Access Compliance Report

Public Rights-of-Way

(Curb Ramps)

Intersection ID: 43155	Main Street: E_W_T_HARRIS_BV	Cross Street: LINDA_LAKE_DR	Location: NE
ADA ID: DB702EE56BAD	Ramp Type: PerpDiag	Initial Pass/Fail: Fail	Overall Compliance: No
Severity Score: 13.75			
Codes/Mitigation Info/Possible Solution		Field Measurements/Component Compliance

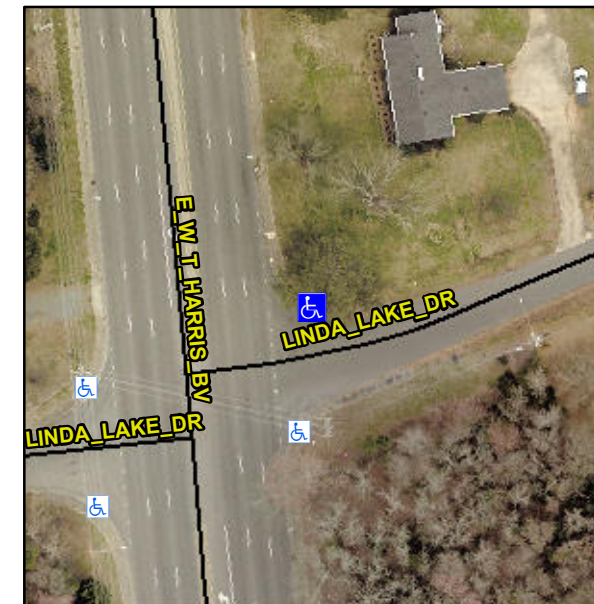
Not Found, R304.2.2, R304.5.3

Compliance	Description	Data	Compliance	Description	Data
N/A	Ramp Length (in)	60.0	No	Ramp Slope (%)	8.7
Yes	Ramp Width (in)	48.0	No	Ramp XSlope (%)	4.1
N/A	Flare Type LT	N/A	N/A	Flare Type RT	N/A
N/A	Flare Slope LT (%)	N/A	N/A	Flare Slope RT (%)	N/A
N/A	Flare Traversable LT?	N/A	N/A	Flare Traversable RT?	N/A
N/A	Landing Length (in)	N/A	N/A	DWS Provided?	N/A
N/A	Landing Width (in)	N/A	N/A	DWS Contrast?	N/A
N/A	Landing Slope (%)	N/A	N/A	DWS Length (in)	N/A
N/A	Landing X Slope (%)	N/A	N/A	DWS Full Width?	N/A
N/A	Landing Curb? (Y/N)	N/A	N/A	DWS Offset (in)	N/A
N/A	Shared Landing?	N/A			
N/A	Gutter Ponding?	Yes	N/A	Gutter Slope (%)	N/A
N/A	Gutter Lip Ht (in)	N/A	N/A	Gutter X Slope (%)	N/A
N/A	Painted X Walk1?	No	N/A	Painted X Walk2?	No
	X Walk 1 Direction	To W		X Walk 2 Direction	To S
N/A	X Walk 1 Width (in)	N/A	N/A	X Walk 2 Width (in)	N/A
	X Walk 1 Slope (%)	0.8		X Walk 2 Slope (%)	1.0
	X Walk 1 X Slope (%)	1.4		X Walk 2 X Slope (%)	2.7

Remove & Replace Curb Ramp With Two New Directional Ramps or Equivalent.
